PROJ #250258.01	ADDENDUM #2	DATE: 02/09/2026
-----------------	-------------	------------------

PFAS Soil Removal Action

**VAP-2 AREA REMOVAL ACTION  
TVC PFAS Remediation Grant  
NRAA / Cherry Capital Airport**

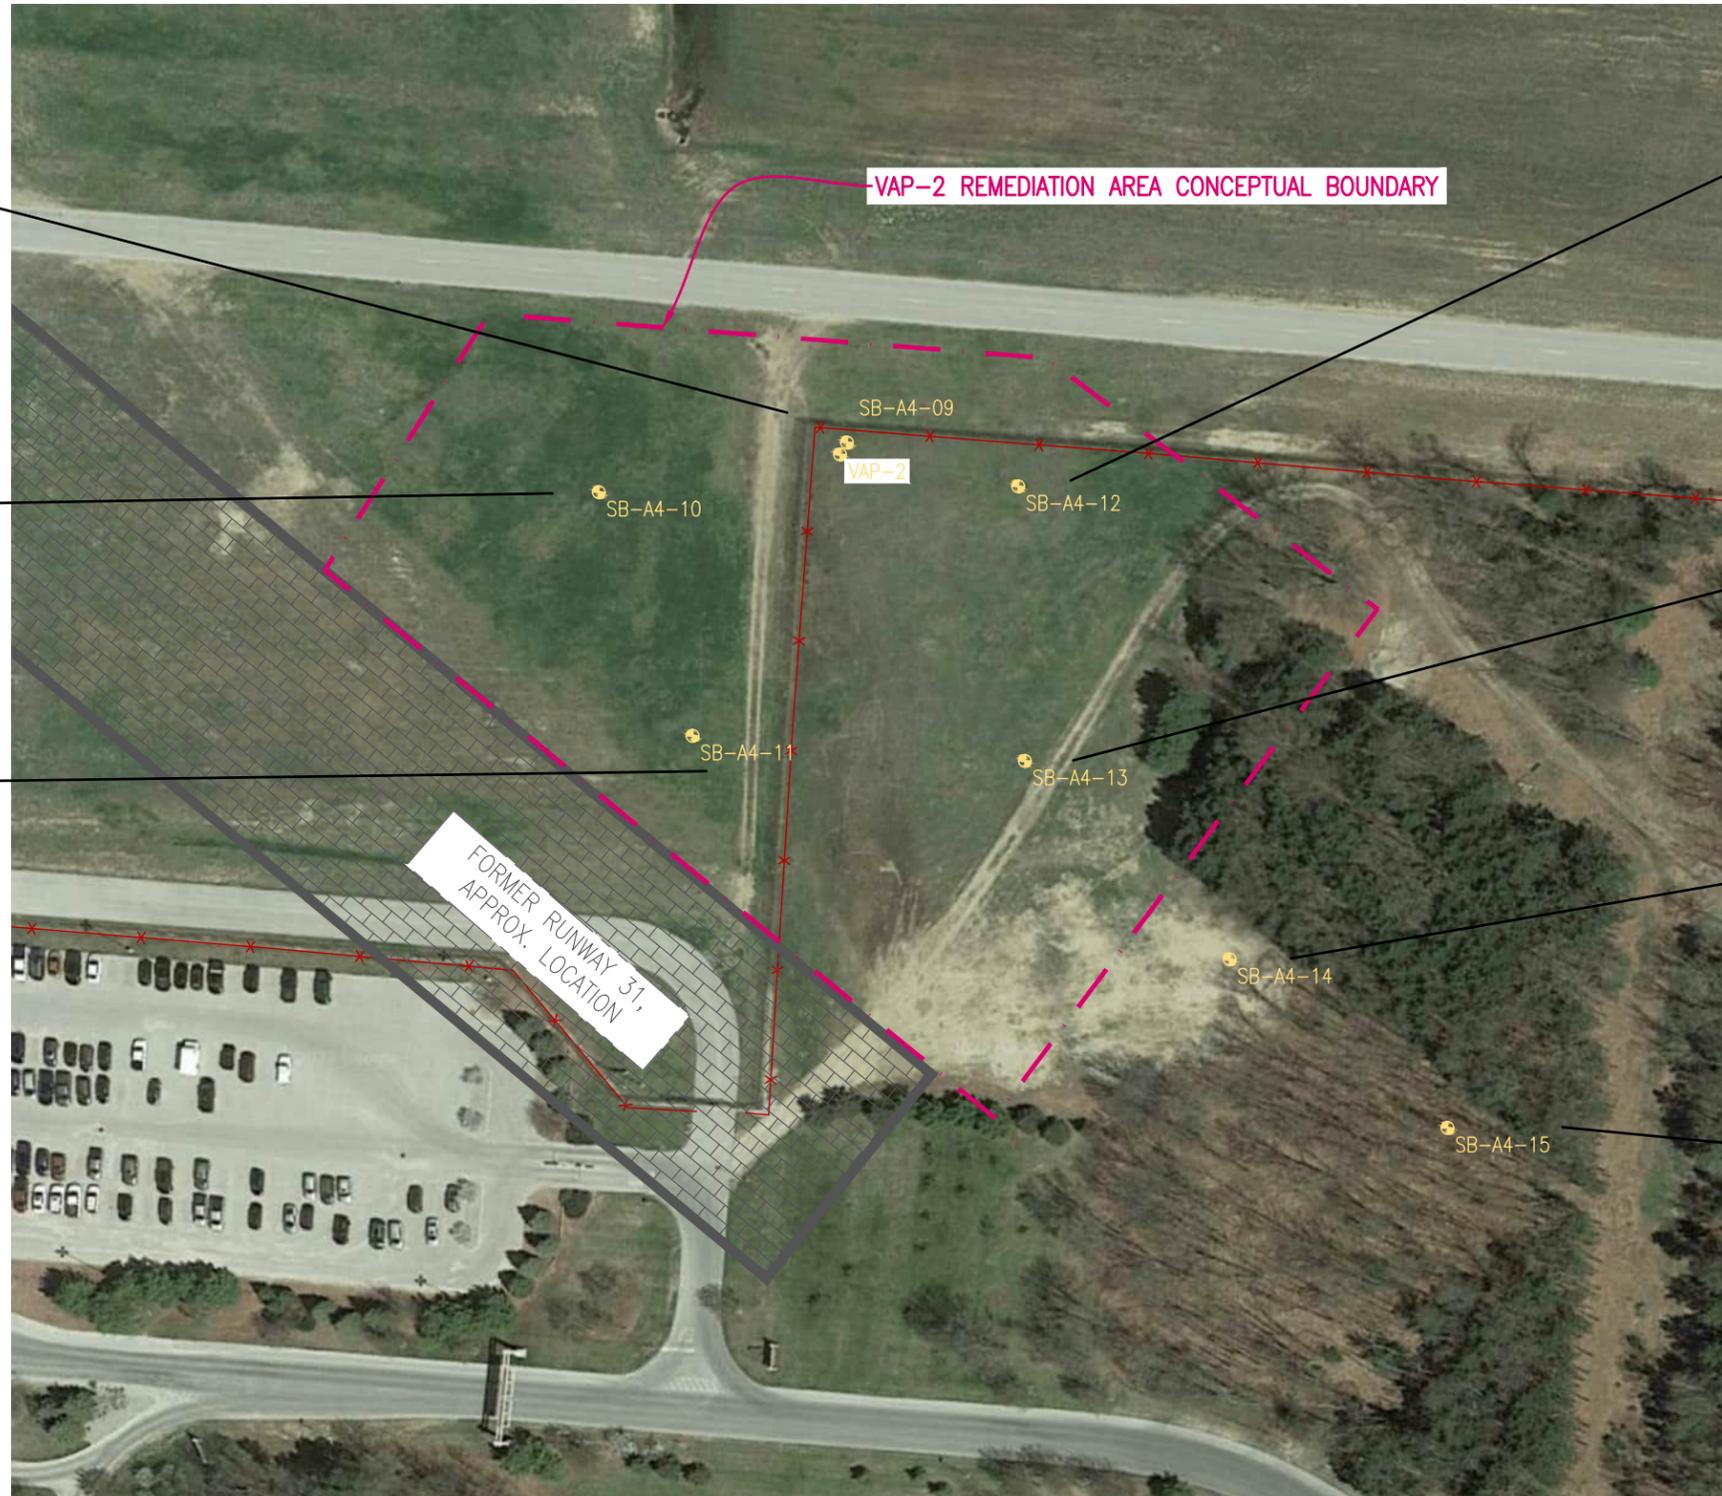
Q1: Article 5.02 (3) indicates Geotechnical Baseline and Geotechnical Data Report are included in the bid documents but are not. Please provide.

R1: Please find the attached Boring Locations and the associated Geotechnical Boring Logs for your review.

**Specification - Prohibited Vehicle Access  
 PFAS Soil Removal Action  
 Northwest Regional Airport Authority**

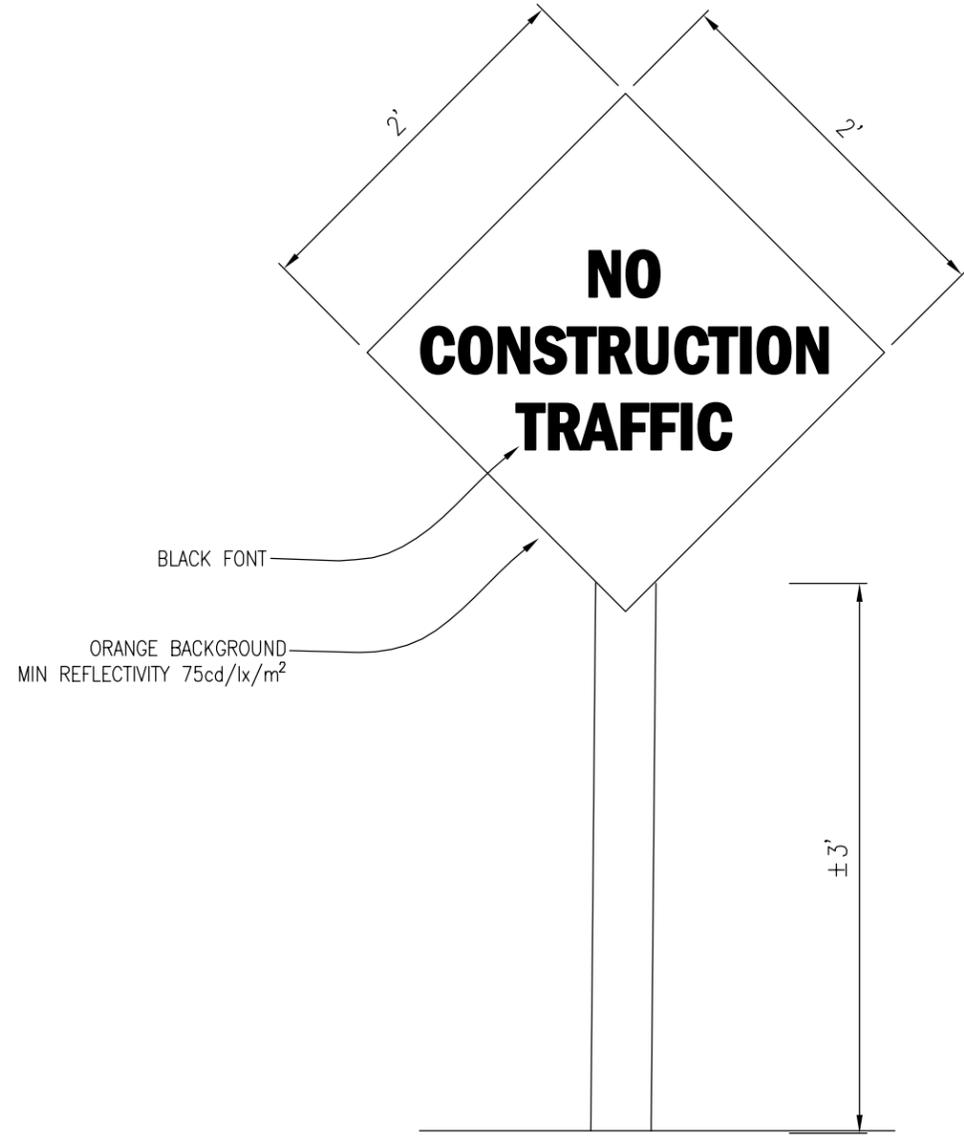
Q15: For the "No Construction Vehicles" sign, what letter/background colors and grade of reflective sheeting are to be used?

R15: An orange background and black font with a reflectivity not less than 75cd/lx/m2 as specified in Table 2A-5 of the Michigan Manual on Uniform Traffic Control Devices.

MATERIAL COMPOSITION & THICKNESS: SIGN SUBSTRATE SHALL BE FABRICATED FROM HIGH-GRADE 5052-H38 ALUMINUM ALLOY WITH A NOMINAL THICKNESS OF 0.075" (14 GAUGE). ALL EDGES MUST BE DE-BURRED AND CORNERS RADIUSED TO 1" MINIMUM TO ENSURE SAFETY AND DURABILITY, OR AS APPROVED BY THE ENGINEER.

DIMENSIONAL STANDARDS: STANDARD SIGN DIMENSIONS ARE ESTABLISHED AT 2' x 2' (24" x 24") AS SHOWN IN THE DETAIL. MINOR DEVIATIONS IN HEIGHT OR WIDTH TO ACCOMMODATE SPECIFIC SITE AND SUPPLIER CONSTRAINTS ARE PERMISSIBLE, PROVIDED THEY MAINTAIN THE INTENDED VISUAL IMPACT.

REGULATORY COMPLIANCE: ALL SIGNAGE DESIGNATED TO BE PLACED ON OR NEAR ROADWAYS ADJACENT TO OR WITHIN THE PROJECT SHALL BE IN CONFORMANCE WITH THE MOST RECENT EDITION OF THE MICHIGAN MANUAL OF UNIFORM TRAFFIC CONTROL DEVICES (MMUTCD) AND MDOT STANDARDS AND REQUIREMENTS
